# HARDEN ADDITION

SEDGWICK COUNTY, KANSAS

Re: S/D 96-53 HARDEN ADDITION (Final Plat)

Re: S/D 96-53 HARDEN ADDITION (Final Plat)

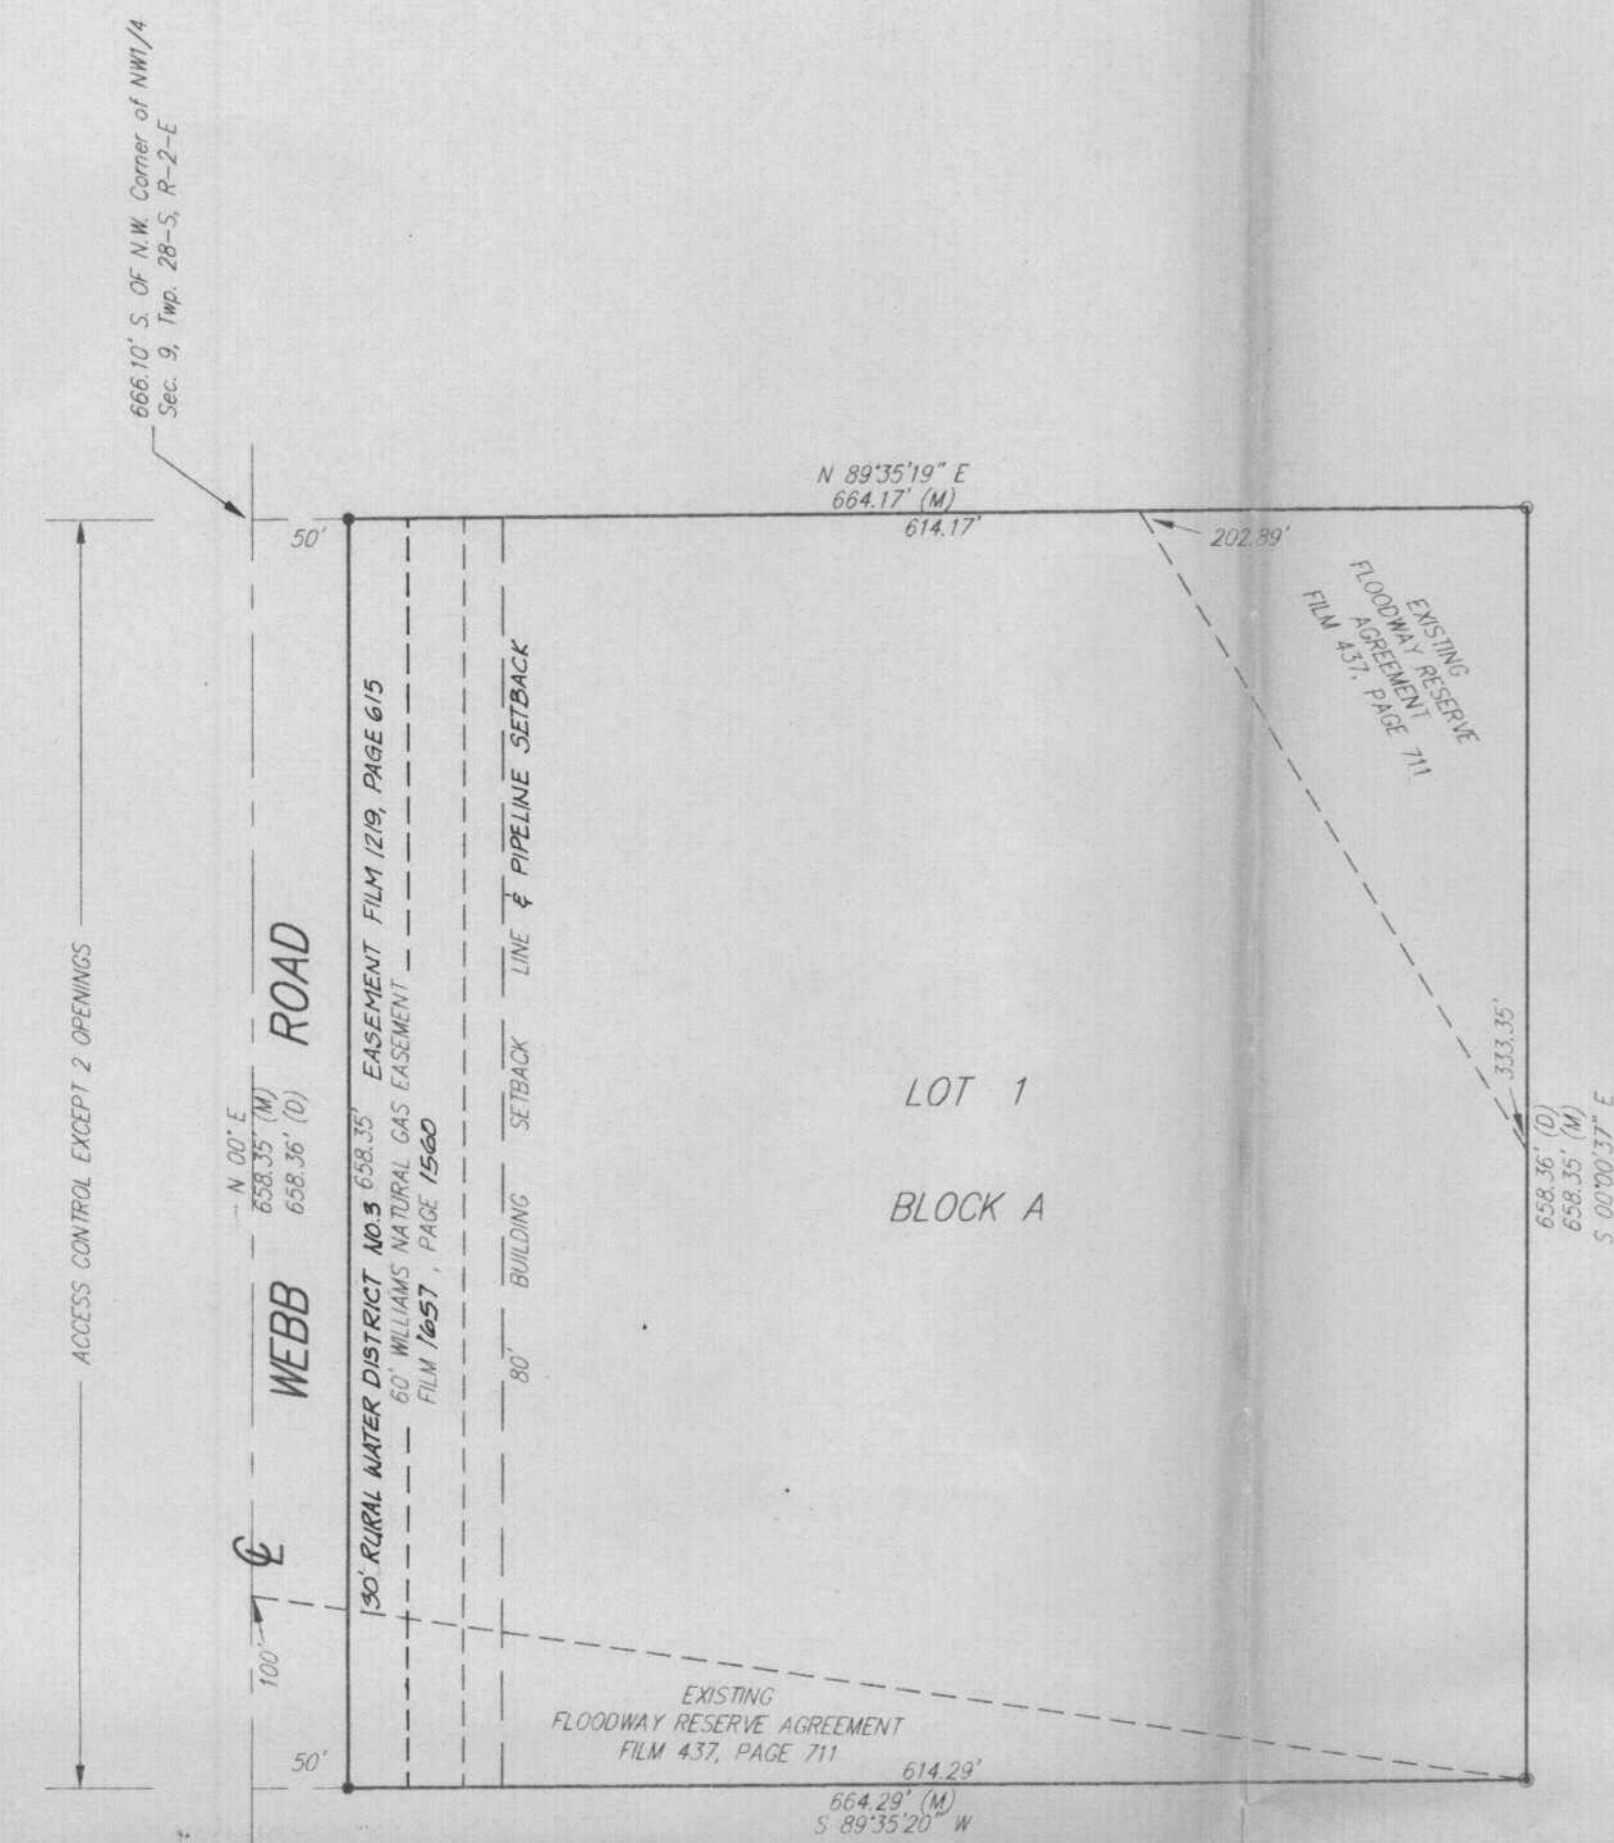
- B. The applicant shall guarantee any drainage improvements required by the platting of this property.
- C. *See survey submitted by agent* At this time, the plat is encumbered by a blanket pipeline easement. The 50-foot easement as now shown is the area to which it is expected that the easement will be confined to. Prior to this plat being scheduled for City Council review, this pipeline shall have been confined as is being noted. The final plat tracing shall, therefore, properly reflect the easement as confined. A copy of the recorded document creating this easement and therefore releasing the blanket easement shall be submitted to Planning. The final plat tracing shall also indicate the easement's recording information and the name of the involved pipeline company.

- D. Any relocation, lowering or encasement of the pipeline, made necessary by this development, will not be at the expense of the County.
- E. The platting binder notes that a rural water district easement is located along the west line of this site. It is not clear, however, if this easement is located on the plat itself or is in street right-of-way. If this easement is on the site itself, in whole or part, the final plat

tracing shall depict the easement and properly label the easement and show the recording information.

- F. On the final plat tracing, the street adjacent to this site shall indicate only the name of Webb Road.
- G. In order to retain a platted setback to Webb Road in the event the pipeline and easement were ever removed, the indicated 80-foot building setback shall be labeled as a "platted and pipeline" building setback.
- H. *OK current to Res. agreement*  
Since a floodway apparently impacts this site, the plat's text shall reference the standard floodway language.
- I. Since a minimum building pad elevation (1362 MSL) is required, both the plat's text and the face of the plat shall note such an elevation.

Also, both on-site and off-site benchmarks shall be provided.
- J. On the final plat tracing, Deputy shall be deleted from the City Clerk's signature line.

- Q. As requested by the utilities, the final plat tracing shall indicate a 10-foot utility easement

along the north line of the plat.
